AMENDMENT NO. 1 MARCH 1980

IS : 8394 - 1977 SPECIFICATION FOR SOLDERING AND WELDING
TYPE TERMINAL ENDS FOR CONDUCTORS OF INSULATED CABLES

(Page 3, Table 2):

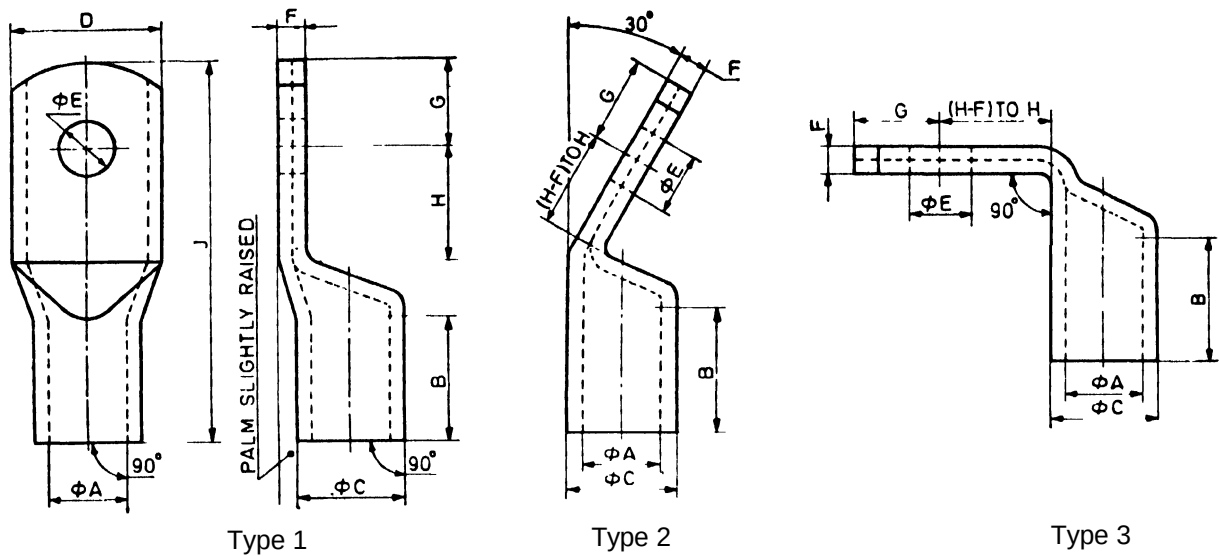
a) Substitute the following for the existing figures:

- b) Designation SCC-400, col 5 — Substitute ' 40 9 ' for ' 40.8 '
- c) Add the following new note under the table:

Note — If the purchaser desires to have the inspection vent, its size and location may be as agreed between the manufacturer and the user.'

(Page 4, Table 3):

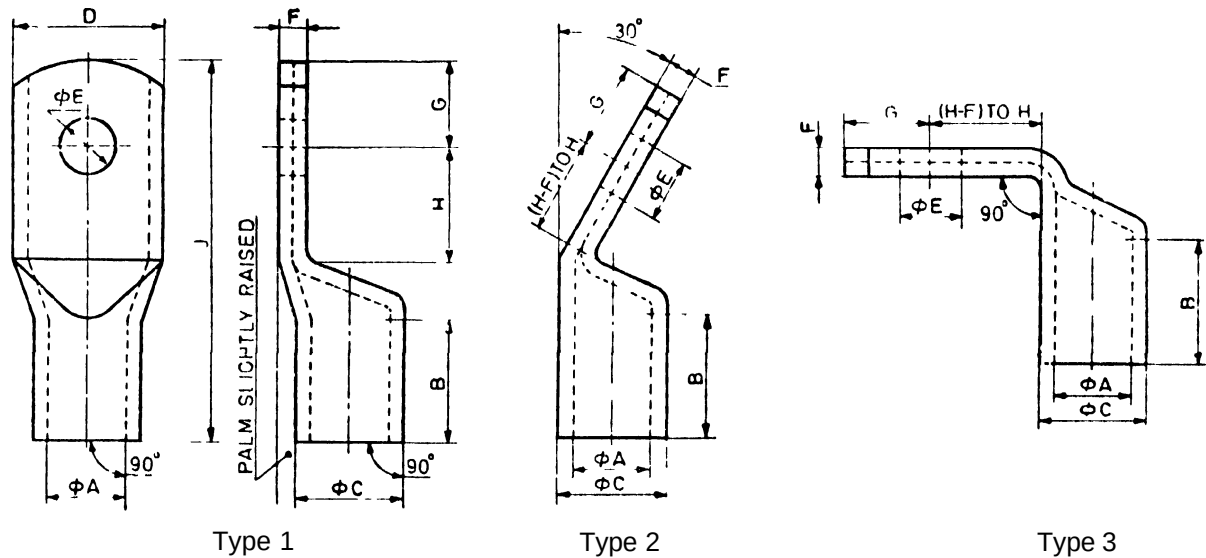
a) Substitute the following for the existing figures:

- b) Designation SCA-6, col 5 — Substitute ' 5.5 ' for ' 3.5 '.
- c) Add the following new note under the table:

'Note — If the purchaser desires to have the inspection vent, its (???) the manufacturer and the user.'
